Subject: Safeguards Plan, Revision 44
Cooper Nuclear Station, NRC Docket 50-298, DPR-46

NEBRASKA PUBLIC POWER DISTRICT SAFEGUARDS PLAN

Revision 44

TABLE OF CHANGES

CHAPTER 13
SECURITY AUDITS

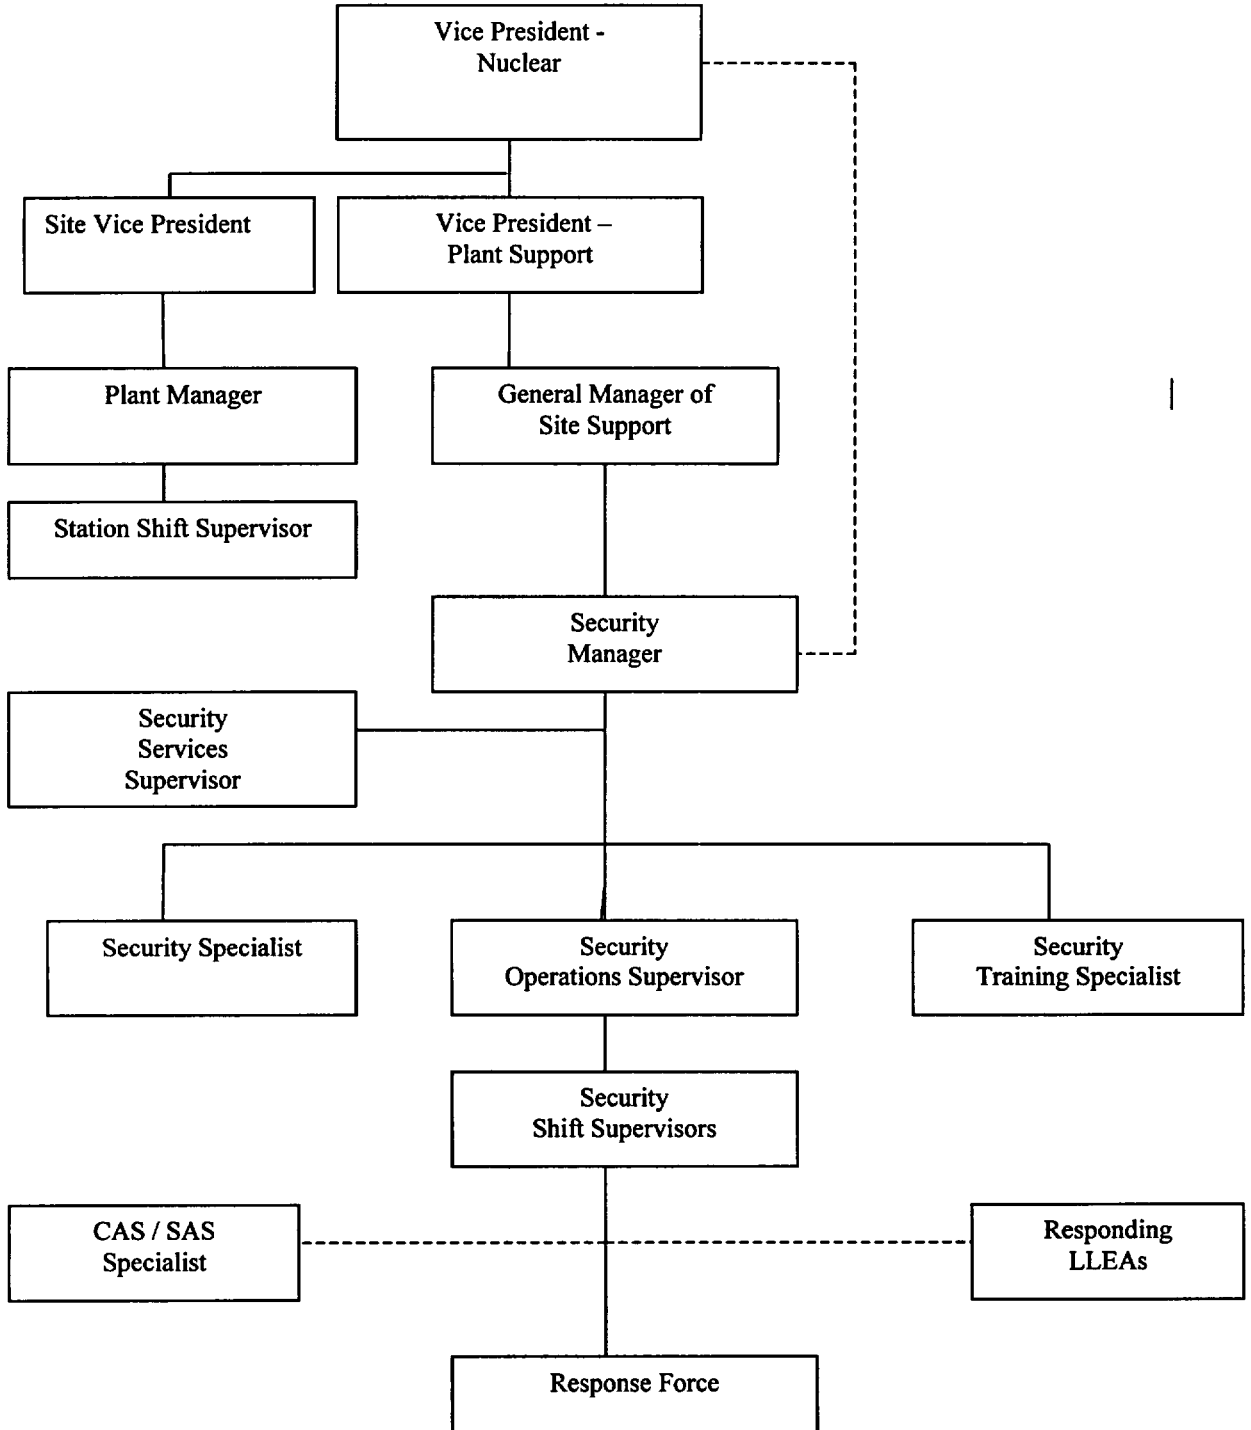
<u>PAGE</u>	<u>DESCRIPTION/REASON FOR CHANGE</u>
I-1-1	Change title of Senior Manager of Site Support to General Manager of Site Support to reflect current organizational structure.
I-13-1	Change title of Senior Manager of Quality Assurance to General Manager of Nuclear Performance Analysis, and change title of Senior Manager of Site Support to General Manager of Site Support to reflect current organizational structure.
I-A-1	Revise Security Organizational Chart to change title of Senior Manager of Site Support to General Manager of Site Support to reflect current organizational structure.
II-1-3	Change title of Senior Manager of Site Support to General Manager of Site Support to reflect current organizational structure.
II-3-1	Change title of Senior Manager of Site Support to General Manager of Site Support, and reflect that this position reports to the Vice President - Plant Support. These changes reflect the current organizational structure.

The monitoring program for station security presently used by the Quality Assurance Department is described in the Quality Assurance Plan. Independent site audits are conducted by the Quality Assurance Department. The Q.A. Manager is independent of Station Management reporting directly to the General Manager of Nuclear Performance Analysis. Audits and surveillance are conducted annually to cover the following types of activities:
